PRODUCT CHANGE NOTIFICATION

Bourns® Model SM453229 and SM453230 Series Chip LAN Transformers *Design and Manufacturing Process Change*

IC219907

Terminal Dimensions of Current Transformer (Top view):

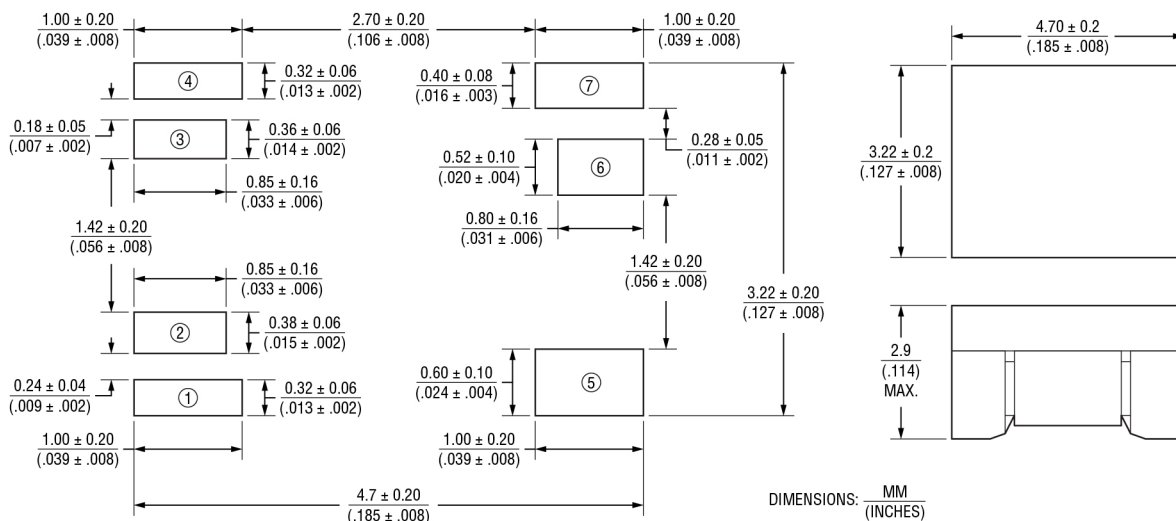
Riverside, California – August 26, 2021 – Effective November 18, 2021, Bourns is changing the core design and manufacturing process for the [Model SM453229 and SM453230 Series Chip LAN Transformers](#) to improve transformer performance and production efficiency. The modified core will include wire grooves on four of the seven terminal pads that can guide the wire leads to the proper position. The core size will be changed slightly.

The recommended layout remains unchanged. The modified transformer can be applied to the existing pad layout.

Bottom View of Current Transformer
Wire lead 1 and 2 entry to terminal pad at end-section

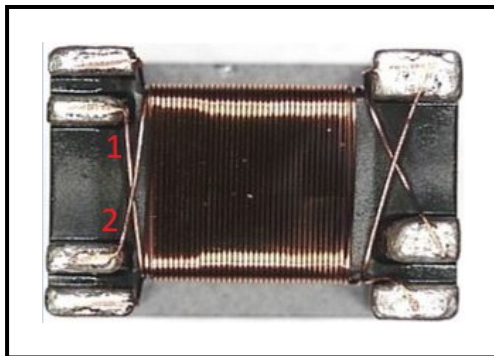
In addition, the manufacturing process will be changed to use winding machines with more spindles to increase the production rate. The transformer winding pattern will be modified as a result of this process change.
